Access Compliance Report

Public Rights-of-Way

(Curb Ramps)

Intersection ID: 44025	Main Street: EASTWAY_DR	Cross Street: EASTWAY_DR_RA	Location: SW
ADA ID: 049E659B3914	Ramp Type: Perp	Initial Pass/Fail: Fail	Overall Compliance: No
Severity Score: 13.75			
Codes/Mitigation Info/Possible Solution		Field Measurements/Component Compliance

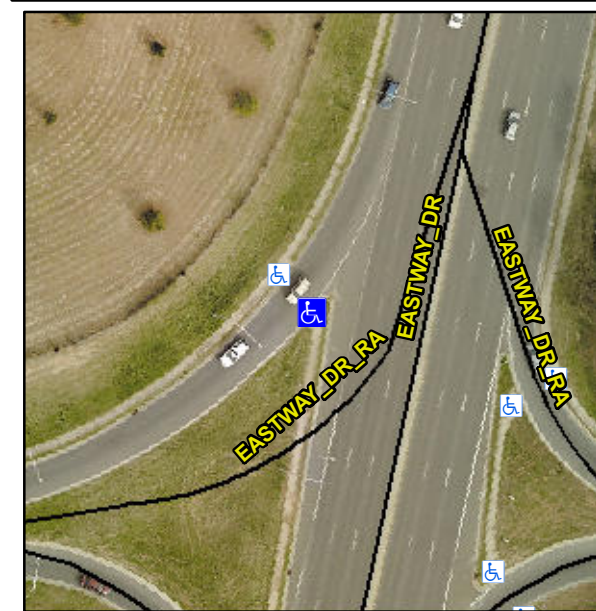
Not Found, R304.2.2, R304.5.3

Compliance	Description	Data	Compliance	Description	Data
N/A	Ramp Length (in)	75.0	No	Ramp Slope (%)	9.0
Yes	Ramp Width (in)	51.0	No	Ramp XSlope (%)	4.1
N/A	Flare Type LT	N/A	N/A	Flare Type RT	N/A
N/A	Flare Slope LT (%)	N/A	N/A	Flare Slope RT (%)	N/A
N/A	Flare Traversable LT?	N/A	N/A	Flare Traversable RT?	N/A
N/A	Landing Length (in)	N/A	N/A	DWS Provided?	N/A
N/A	Landing Width (in)	N/A	N/A	DWS Contrast?	N/A
N/A	Landing Slope (%)	N/A	N/A	DWS Length (in)	N/A
N/A	Landing X Slope (%)	N/A	N/A	DWS Full Width?	N/A
N/A	Landing Curb? (Y/N)	N/A	N/A	DWS Offset (in)	N/A
N/A	Shared Landing?	N/A			
N/A	Gutter Ponding?	N/A	N/A	Gutter Slope (%)	N/A
N/A	Gutter Lip Ht (in)	N/A	N/A	Gutter X Slope (%)	N/A
N/A	Painted X Walk1?	No	N/A	Painted X Walk2?	N/A
	X Walk 1 Direction	To NW		X Walk 2 Direction	N/A
N/A	X Walk 1 Width (in)	N/A	N/A	X Walk 2 Width (in)	N/A
	X Walk 1 Slope (%)	4.7		X Walk 2 Slope (%)	N/A
	X Walk 1 X Slope (%)	3.8		X Walk 2 X Slope (%)	N/A

Remove & Replace Entire Ramp.
